BKC Sweater Ltd

03 May 2014

Observations

Floor build-up and equipment

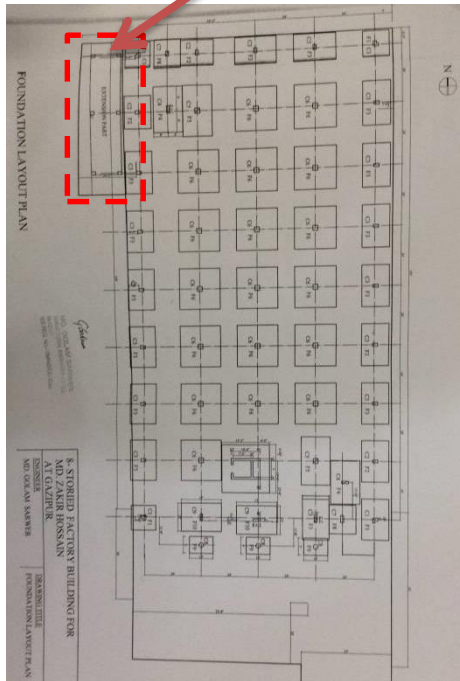
Design check required for floor build-up and equipment loading in washing area on 1st floor

100mm (approx) floor build-up in Washer Area and equipment loads supported by concrete slab on 1st floor.

Building Engineer to check that the slab has been adequately designed and constructed to carry additional load due to floor build-up and equipment.

Building Engineer to prepare controlled loading plans, based on floor slab and column capacity, for all floors which will designate allowable storage density and where storage may be placed.

Foundation plan

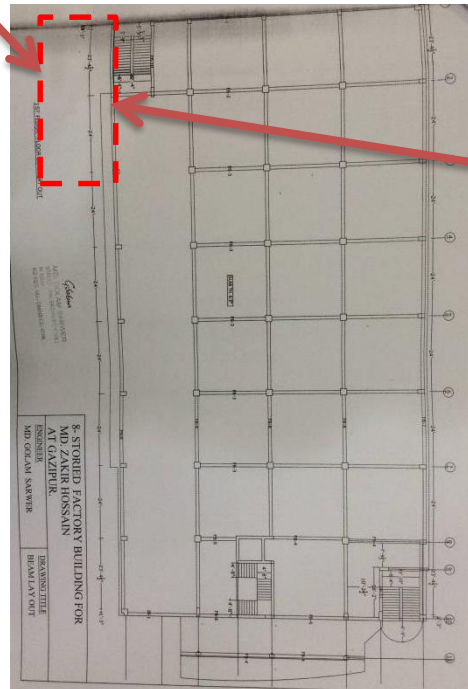
Minor inconsistencies between structural drawings and the as-constructed structure

Foundation pads for the Boiler annex (extension) are shown on foundation plan but upper floor structures are not shown on the typical floor plan.

Building Engineer to survey as-built structure and update drawings including design verification

Structural drawings not consistent with 'as constructed structure'

**Evidence of movement at joint
between the Main building and the
Boiler Annex.**

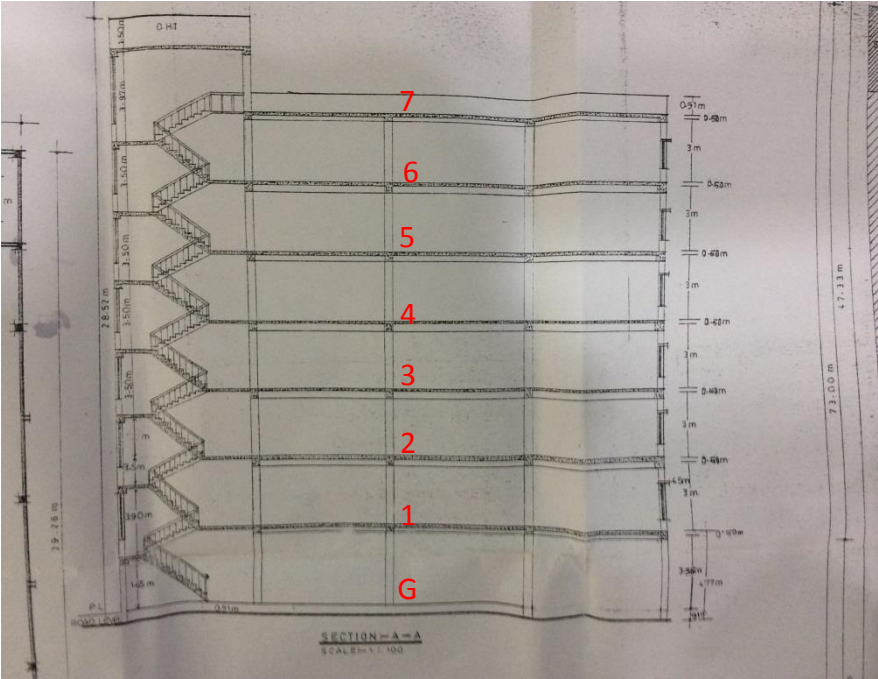
Movement between main factory and Boiler Annex

**Cracks on the interface between Main
building and Boiler Annex**
